Access Compliance Report

Public Rights-of-Way

(Curb Ramps)

Intersection ID: 2897	Main Street: BELL'S_MILL_DR	Cross Street: HARBURN_FOREST_DR	Location: NE
ADA ID: 7AEA0AF07137	Ramp Type: PerpDiag	Initial Pass/Fail: Pass	Overall Compliance: No
Severity Score: 15.25			
Codes/Mitigation Info/Possible Solution		Field Measurements/Component Compliance

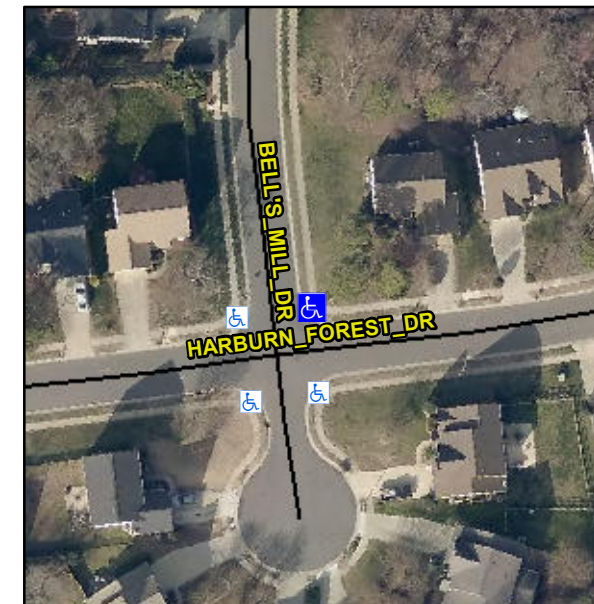
Not Found, R304.5.3, R304.2.1, R305, R304.5.4

Compliance	Description	Data	Compliance	Description	Data
N/A	Ramp Length (in)	44.0	Yes	Ramp Slope (%)	8.1
Yes	Ramp Width (in)	48.0	No	Ramp XSlope (%)	2.9
N/A	Flare Type LT	Sloped	N/A	Flare Type RT	N/A
N/A	Flare Slope LT (%)	3.4	Yes	Flare Slope RT (%)	5.4
N/A	Flare Traversable LT?	Yes	N/A	Flare Traversable RT?	Yes
Yes	Landing Length (in)	48.0	No	DWS Provided?	No
No	Landing Width (in)	43.0	N/A	DWS Contrast?	No
Yes	Landing Slope (%)	2.0	N/A	DWS Length (in)	N/A
No	Landing X Slope (%)	3.1	N/A	DWS Full Width?	No
N/A	Landing Curb? (Y/N)	No	N/A	DWS Offset (in)	N/A
N/A	Shared Landing?	No			
Yes	Gutter Ponding?	No	No	Gutter Slope (%)	8.9
Yes	Gutter Lip Ht (in)	0.0	Yes	Gutter X Slope (%)	0.3
N/A	Painted X Walk1?	No	N/A	Painted X Walk2?	No
	X Walk 1 Direction	To W		X Walk 2 Direction	To S
N/A	X Walk 1 Width (in)	N/A	N/A	X Walk 2 Width (in)	N/A
	X Walk 1 Slope (%)	2.5		X Walk 2 Slope (%)	4.6
	X Walk 1 X Slope (%)	4.0		X Walk 2 X Slope (%)	2.8

N/A	Ramp inside XWalk1?	N/A	N/A	Ramp inside XWalk2?	N/A
	Road Slope (%)	0.2	N/A	Clear Space?	Yes
	Road X Slope (%)	4.2	N/A	Clear Space to XWalk (in)	N/A
Yes	Any Obstructions?	No	Yes	Storm Grate/Utility Hazard?	No
	Obstruction Type			Storm Grate/Utility Type	
		N/A			N/A
			Yes	Surface Condition? (G/P)	Good

Remove & Replace Curb Ramp With Two New Directional Ramps or Equivalent. Remove & Replace Gutter.
